# ***Interactive comment on “Impact of LUCC on Streamflow using the SWAT Model over the Wei River Basin on the Loess Plateau of China” by Hong Wang and Fubao Sun***

To: Hydrology and Earth System Sciences (HESS) Subject: Revise the manuscript (#hess-2016-332) The Authors: Wang & Sun The Title: Impact of LUCC on Streamflow Based on the SWAT Model over the Wei River Basin on the Loess Plateau of China Response: The authors appreciate Dr. Lacombe for helpful criticism and 8-pages constructive comments that improved our original manuscript. We have addressed the comments below and have made corrections. The changes being made are marked in red in the manuscript. Response to the main comments: 1: First of all, I am questioning the significance of the hydrological changes that actually occurred in the catchment over the studied period. Although figure 1 indicates that forested areas increased by

**Fig. 1** The development of soil and water conservation measures in the main stream basin of Wei River over last 50 years.

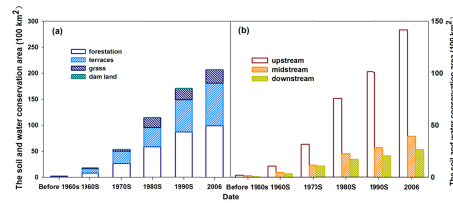
about 65.104 hm<sup>2</sup> (unusual unit used on the Y axis), which is equivalent to 14% of the upper catchment area, figure 3 inconsistently shows that forested area increased by only 0.81% (line 137) over the same period (1980 to 2005). How to explain this difference? If we rely on figure 2 (which is likely the most reliable source), we can expect minor influence of forestation on the basin hydrology. Thank you for pointing this out, which makes us think it through. In fact, these two datasets are from different sources. First of all the number in Fig. 1 is for 6.53% (instead of 14%) as shown in detailed explanation below, which is still higher than 0.81% as pointed by the referee. This is a classic issue in the national survey on soil and water conservation where they only take the revegetation implemented into account and ignore for example possible death of vegetation, which is important in the land use map. One more thing is that the national survey when counting the revegetation areas does not consider the vegetation coverage, which is in fact important in any hydrological modelling including the SWAT modelling. We agree with the referee on that point. With that caution, however, Figure 1 is just for a reference on the development of the soil and water conservation project in China. The data we are relying on are the land use maps. Detailed explanation below: (1) There are some detailed descriptions about Fig.1. The same legends for Fig.1 (a) and (b) brought some confusion, so we revised the legends of Fig. 1. Figure 1 is the developing process of the soil and water conservation measures in the main stream basin of Wei River, including the upper and middle reaches (4.68×10<sup>4</sup> km<sup>2</sup>) and the downstream of the main stream (1.65×10<sup>4</sup> km<sup>2</sup>). Figure 1 involves about 6.33×10<sup>4</sup> km<sup>2</sup>. Figure 1 (a) is the area developing of forestation, terraces, grass and dam land separately. The area of forestation was about 57.43×10<sup>4</sup> hm<sup>2</sup> during 1980s and it increased to 98.75×10<sup>4</sup> km<sup>2</sup> in 2006, which equivalent to 6.53% of the main stream basin of Wei River. And Fig. 1 (b) is the sum area of the forestation, terraces, grass and dam land in upstream, midstream and downstream. And the sum area increased by about 66.15×10<sup>4</sup> hm<sup>2</sup> in upstream.

Fig. 1 The development of soil and water conservation measures in the main stream basin of Wei River over last 50 years. (2) Figure 1 is the statistical data of government

based on natural forest before and artificial planting area, which involves all planting of forestation without considering canopy density, surviving or deforestation and so on. The forest of the LUC data refers to the natural forest and plantation, which canopy density is larger than 30% (Table 3: note 1). (3) The forest data of Fig. 1 also includes planting land used as agro-fruit, agro-mulberry, agroforestry and replanting land for trees. While land used for agro-fruit, agro-mulberry, agroforestry is classed as Agricultural land (Table 3: note 2) in LUC. (4) There are also some screening conditions for land use types dividing in SWAT model. For hydrological response unit (HRU) analyst, the Dominant Land Use method was used for HRU definition. So the dominant unique combination of land use in the subbasin is used to simulate the HRU. Figure 1 shows the area of grass is smaller than forest's, while it is opposite in LUC and SWAT model attributed to canopy density and the Dominant method.

**Fig. 1.**

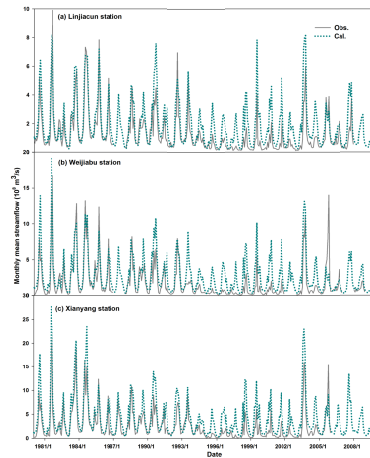
(Line 331-332). They were 3 control conditions when the land use converted from agricultural land to forest. The second and third conditions were considered as much as possible to reduce impacts of other factors. (32) Line 306: the authors indicate that the actual change in forest cover calculated using the land-use maps displayed in figure 3 (0.8% increase) would lead to less than 1% change in streamflow. I agree with this realistic statement but: is it consistent with the hydrological change quantified in line 270? Thank you for your suggestion. Line 306 is the result of conversion of agricultural land to forest on streamflow. Line 270 is the result of LUCC changes on streamflow, which involves many types of land use conversion measures and is a balanced result among these measures. So the changes of streamflow, surface runoff, soil flow and baseflow between agricultural land and forest were singled out (Fig. 9 The changes of 30-year (1980-2009) averages of streamflow, surface runoff, soil flow and baseflow between agricultural land and forest.). We can see the impacts are consistent. (33) Lines 314-325. the authors explain differences in hydrological behaviour of the Loess Plateau and earth-rock mountain, based on other publications, but this paragraph is not linked to the result of the study. The authors need to evidence how these distinctive hydrological behaviours influence their results. Thank you for your suggestion. As suggested, we revised the whole manuscript carefully and add more details to make it clean. Figures (34) Fig. 1: Areas under different treatments are expressed in 104 hm<sup>2</sup> (i.e. squared hectometers?). This is an atypical unit which is different from the unit used for the study area in the text (104 km<sup>2</sup>). All areas should be provided in same unit to allow easier comparison. It would be clearer to provide the percentage area so that we anticipate the possible effect of the land treatment on the catchment hydrology. Thank you for your suggestion. Figure 1 is revised as suggestion.

Fig.1 (35) Fig.2. What is the meaning of all small numbers written on the map of the study area? If they correspond to hydrological units, it is surprising to see numbers in the downstream part which is not included in the study area. Thank you for your suggestion. The numbers of Fig. 2 are serial number of subbasins/ HRUs (Line 208). All numbered area is study area. Linjiacun station locates at the control section of
